**Route 29 Project Delivery Advisory Panel
September 11, 2014
Meeting Minutes**

Route 29/Rio Intersection Design

Southern Environmental Law Center
Kennon Williams Landscape Studio

PRELIMINARY SKETCH - Overpass Facade

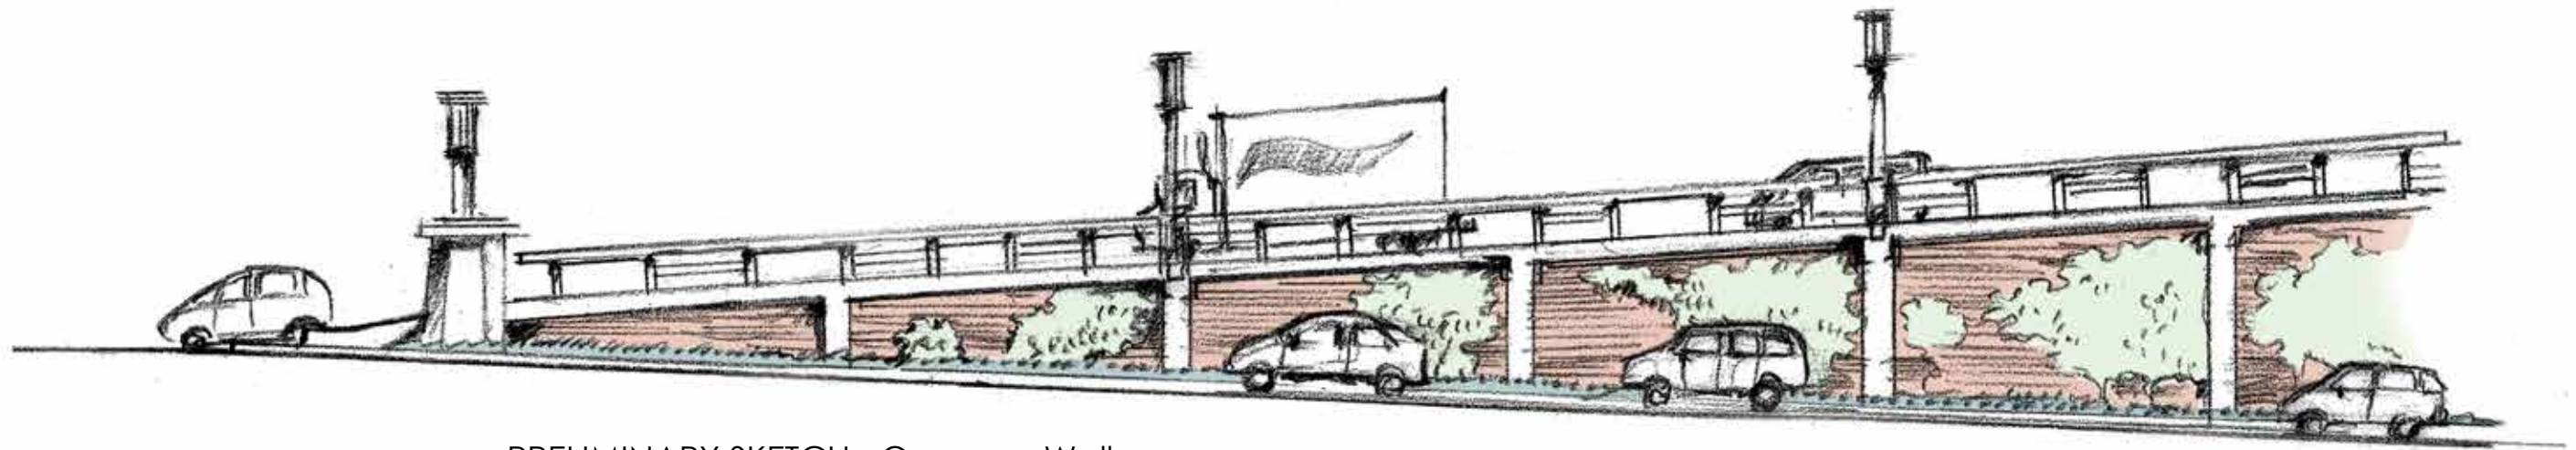
- 3. Architectural elements:**
 - a. Articulated overpass façade that looks like a bridge. (*See sketch and photo examples.*)
 - b. Break up the mass of the retaining wall facings with some articulation (e.g., column-like relief in front of façade of textured concrete or brick or stone). Consider growing clinging tough vines such as Boston Ivy on walls between columns. (*See sketch and photo examples.*)
